<b>Secure 1000 Radiation Emission Measurement</b>	FORM R-0646-1 (Single Pose)
---	---	--------------------------------

**Re: Rapiscan AIT System Radiation Survey Reporting**

## R-0646-1 Addendum (Documentation Errors)

Product Name	Secure 1000SP (Single Pose)
Serial Number	<b>S51011007</b>
Radiation Emission Measurement	Radiation Survey Dated: 08/25/2010
RSO Initials

**1. In Beam Dose Measurement: Survey Table. 1**

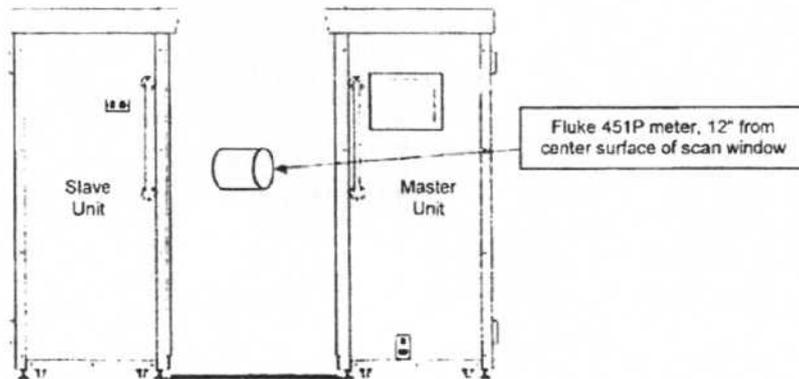
1. No value indicated for background radiation. Typical values range from 7uRem/hr to 13uRem/hr at sea level. Note: Absence of value has no adverse impact on calculations.
2. TABLE 1: Incorrect presentation of data in Column 3 for Measured Exposure. Indicated values are 18 uR and 11 uR. Corrected values are 1.8 uR and 1.1 uR. The values were corrected by technician when calculating Effective Dose.
3. Tech input incorrect calibration date for Radiation meter. Actual calibration date has been verified that it was not due for calibration service.

The service technician should attend refresher training.

The corrected data indicates this system was operating within expected parameters. No re-survey is required for this system.
